Attachment 3

Revision FSAR Chapter 2, Subsection 2.5.4

FIGURE 2.5.4-209

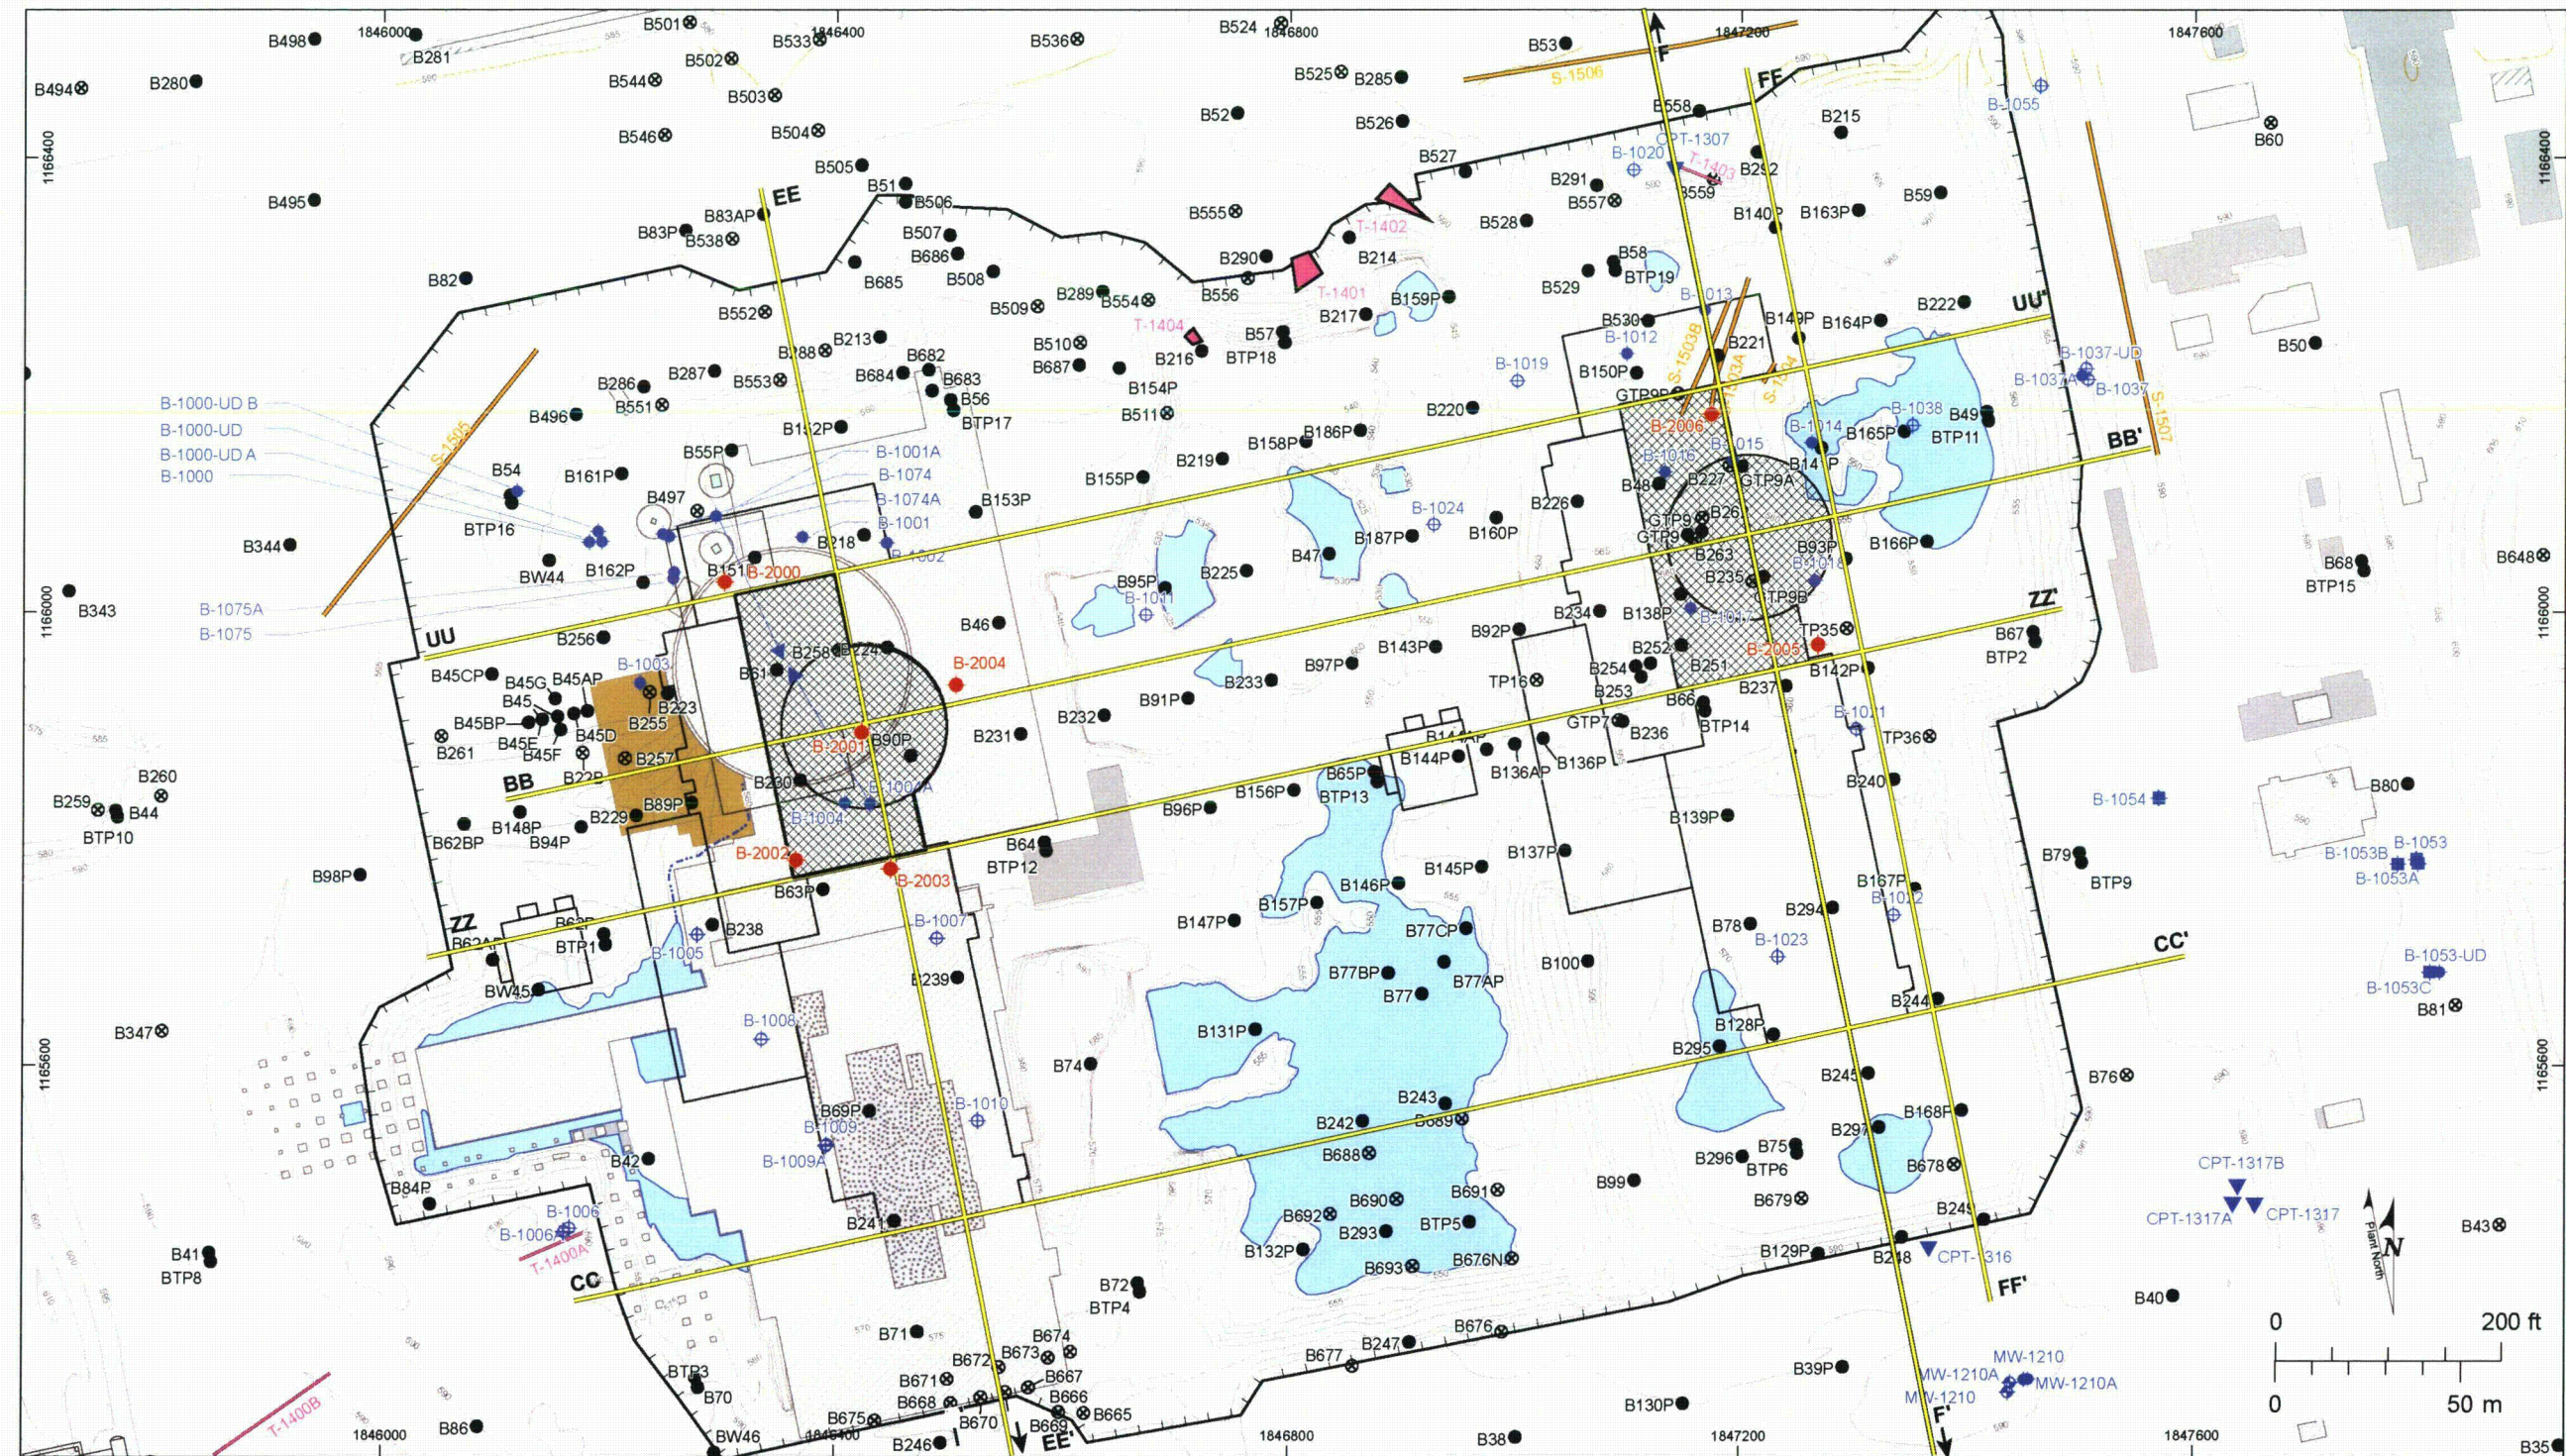
The exploration locations made in 2006-2007 are shown on Figure 2.5.4-208. The locations of the borings made in 2012 are shown on Figure 2.5.4-209 in addition to those made in 2006-2007.

As-built survey data and topographic surveys were used to prepare maps of the final geotechnical data exploration program as presented in Figures 2.5.4-208 (2006-2007 explorations only) and 2.5.4-209 (2012 explorations in addition to 2006-2007 explorations). The locations of exploratory borings, monitoring wells, test pits, and surface geophysical lines were recorded in digital format. These data were uploaded into a geographic information system (GIS). The GIS was used to prepare plan view maps and profile drawings that were used to develop geologic interpretations.

76. COLA Part 2, FSAR Chapter 2, Figure 2.5.4-209 is revised as follows:
